Index 219

Curb and Gutter Barrier Inlet

COMMENTS AND RESPONSES

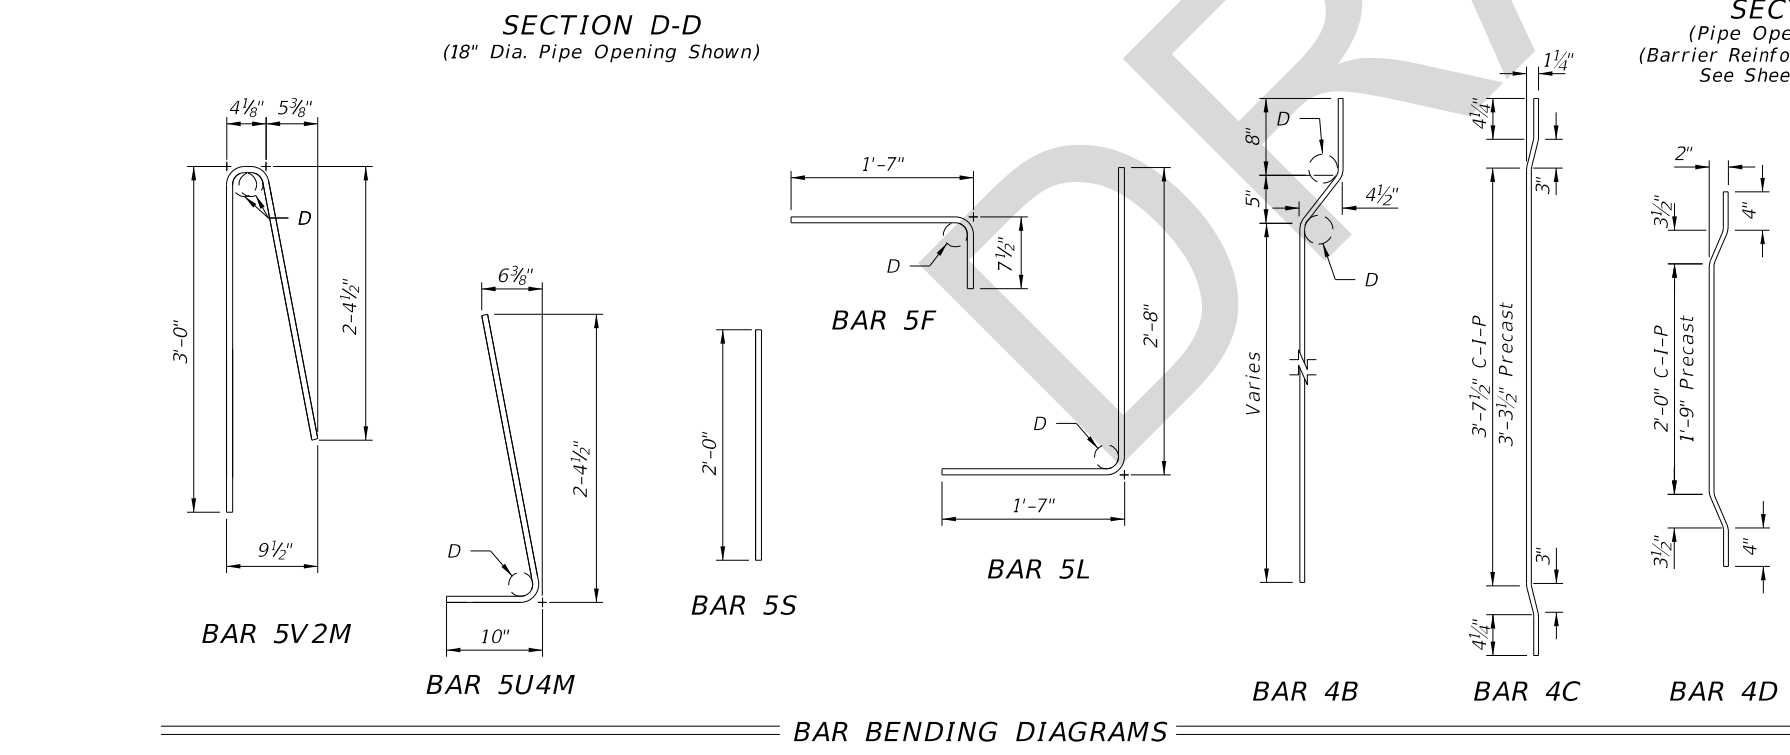
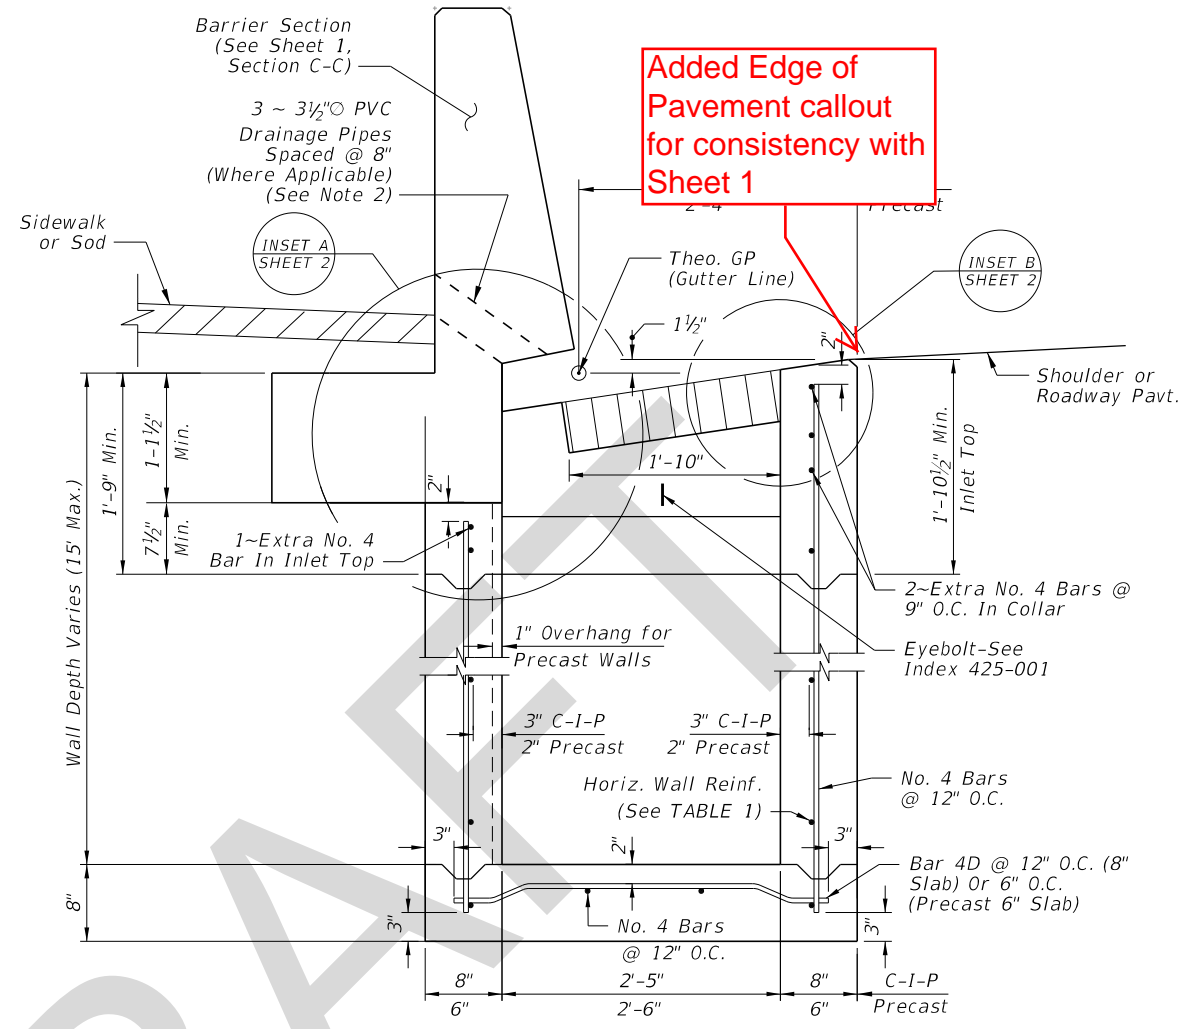
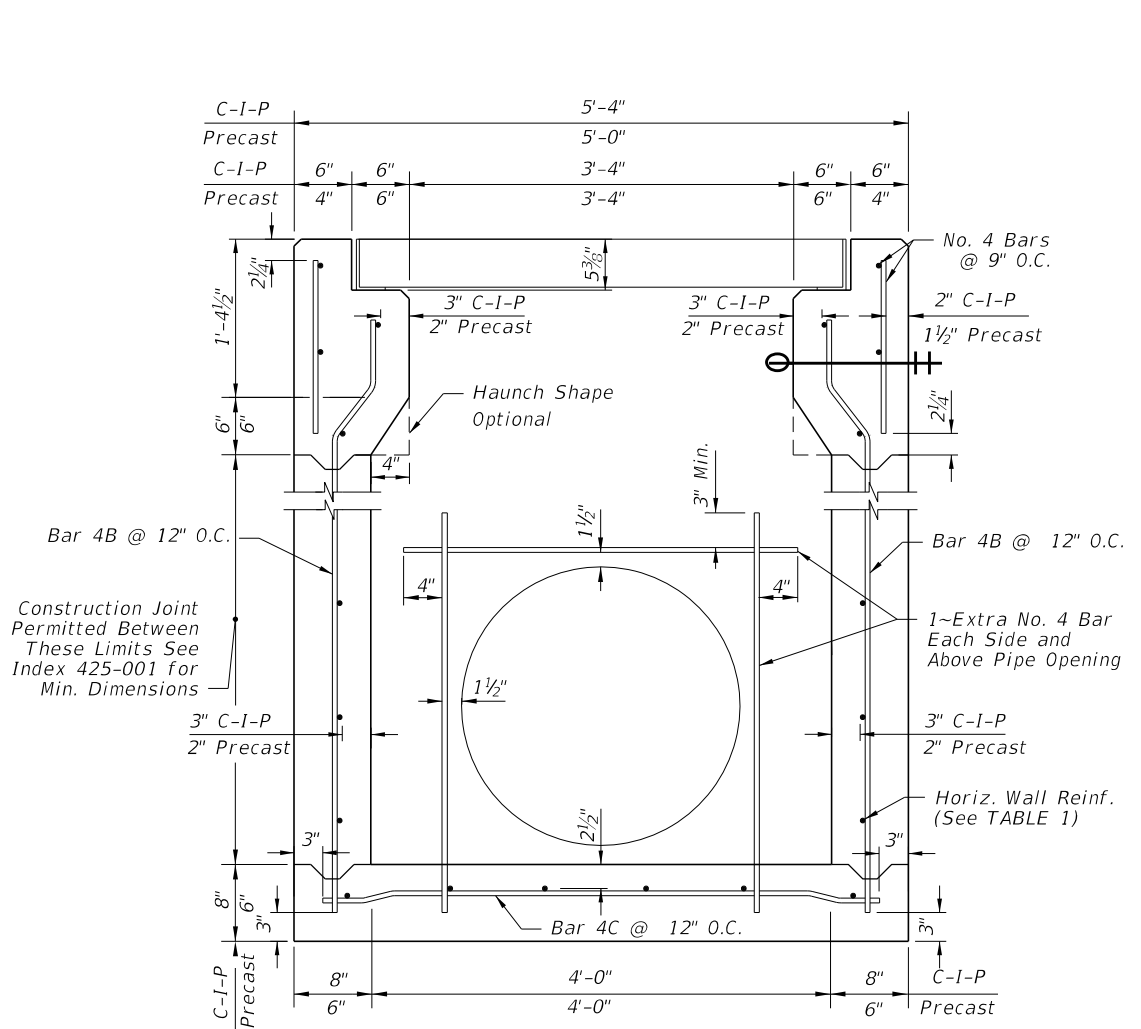
425-032 Sheet 1: Use fewer (contour) lines in isometric view

Superficial aesthetic. Okay as-is.

SECTION E-E
(Pipe Opening Not Shown)
(Barrier Reinforcing Steel Not Shown,
See Sheet 1, Section C-C)

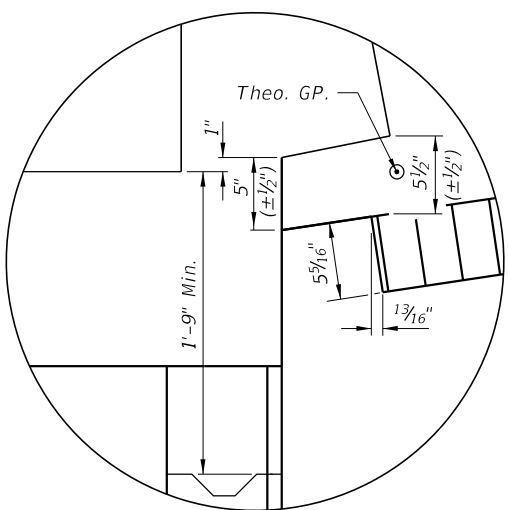
1. Sheet 1 of 3 (Section C-C): Label the “sidewalk or sod”.
2. Sheet 2 of 3 (Section E-E): Remove the label “shoulder or roadway pavement” and show “edge of pavement”, for consistency with Sections A-A and B-B on sheet 1.

1. Paper space is restricted, and the trend established with identical shapes and patterns in Sections A-A and B-B make the “Sidewalk or Sod” area in Section C-C apparent. Okay as-is.
2. Label “Shoulder or Roadway Pavement” okay as-is for curbed segment. Added “Edge of Pavement” label for continuity with Sheet 1. Change made.
